Submission to Standards New Zealand
with regard to
draft Standard DZ 6808:2009
Acoustics – Wind farm noise

from
Philip J Dickinson Ph.D., FASA

Figure 1

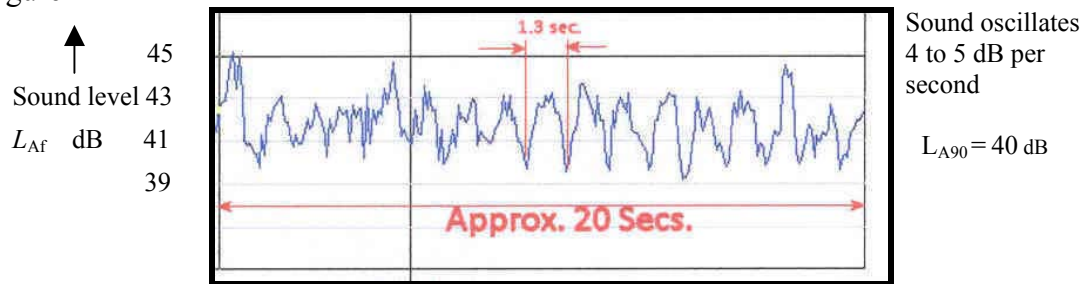
Figure 1 [6] shows a typical windfarm noise time history over a few seconds. The L90 is this case is about 3 dB below the average maximum level (L10) but in may cases it is about 5 dB below. So in many windfarm standards across the world (including this draft) the design criteria is set as an L90 of the background level + 5 dB or 40 dB whichever is greater – again theoretically the maximum one can get away with, without there being very severe repercussions from the community. At such levels there will be severe annoyance, but most people will knuckle down realising that there is almost nothing they can do about it without it costing them quite a lot of money. It does not limit annoyance and it does not protect public health.

The draft assumes 10 to 15 dB attenuation through an open window and that the background masks the windfarm noise to such an extent, that it is not unreasonable to allow the wind farm to produce 40 dB (L_{A90}) at the property or an increase of 5 dB over the background sound level which ever is the greater. This is equivalent to saying that if the background sound is already over the WHO limits then an extra 5 dB over will not matter. This not sustainable management which under the Resource Management Act:1991 (Section 5) "enables people and communities to provide for ……. their health and safety …." Taking an analogy from an Environment Court judge, this is equivalent to hitting someone over the head with a hammer and saying it is all right to hit them 7 times as hard (5 dB) as they won't notice the difference.

- • Once again we come back to the philosophy that the design limit should be no more than the World Health recommendation of 30 dB (L_{Aeq}) and this should be the level outside any residence.

Figure 9

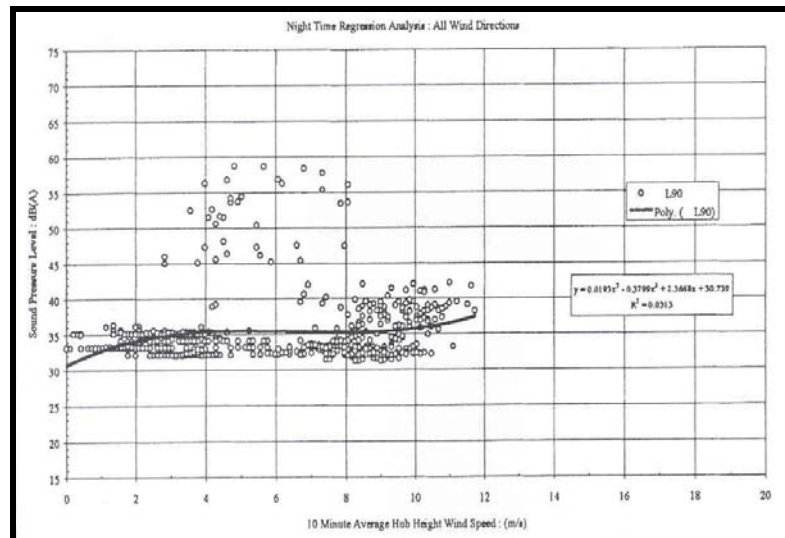
Figure 9 below shows another data pair graph as would be used for a resource consent hearing. [ibid]

On this graph there is an even greater scatter – more than 20 dB on several occasions – but more worrying is the possibility that the instrumentation used in the unaccompanied monitoring has not truly measured the background sound level at all.

First of all it would appear that the instrumentation did not have a sufficiently low noise floor to record all the sounds at their true level. It will be noticed there is no scatter of results below 32 dB, but tremendous scatter above 40 dB. This suggests the noise floor of the instrumentation used was as high as 32 dB, so anything below 28 dB was recorded as 32 dB or anything between 28 and 32 dB recorded as 33 dB or over. The background sound level may well have been well below 25 dB, even below 20 dB, but the instrumentation has recorded it as being 32 dB. This has artificially raised the value of the background sound level possibly by several dB. It may be noted that some of the equipment seen to be used by noise consultants in New Zealand for such purposes, has this limitation.

- Wind farms should be given a fixed level to meet at any residence in all conditions at all times - not one based on a supposed relationship between the wind speed at the hub of the turbine and the background sound level at the recipient - and this level should be no more than 30 dB ($L_{Aeq,10min}$).

A total rewording of section 3 is needed, removing all references to L90. An entirely new measurement and prediction methodology is also required.

Figure 10

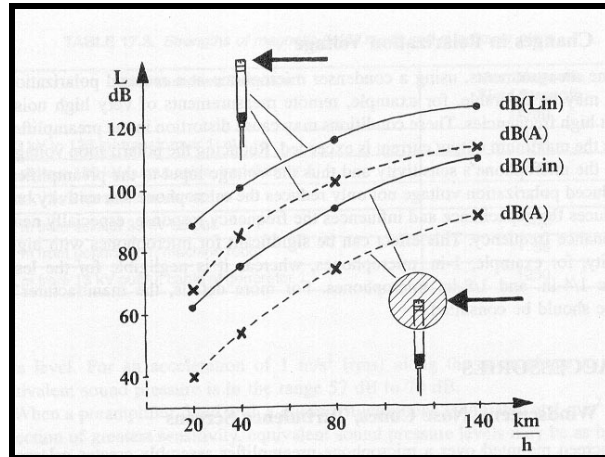
Secondly, those using sound level meters have to be very careful that the wind at the microphone does not exceed 5 metres/second (18 km/hr) when measuring sounds between 40 dB and 50 dB, and not exceed 3 metres/second (11 km/hr) when

measuring sounds between 30 dB and 40 dB, even with a good windshield in place. Figure 10 below shows the effect of a wind shield on a sound level meter [9]. If the wind at the microphone is 20 km/hr, the sound level meter will register 40 dB without any other sound present even with a windshield in place.

The draft Standard places no limits to the wind speeds in which the measurements are to be taken. If the wind is over 5 metres per second, much of the measurement will be noise from the wind on the microphone and not the background level at all – even with a very good windshield in place. The background sound level is being artificially raised even more – again to the benefit of the noise maker. Such rank manipulations would not be acceptable from any other industry so why is it allowed in the current standard for windfarms and carried over into the new draft? It is mathematically, scientifically and ethically wrong
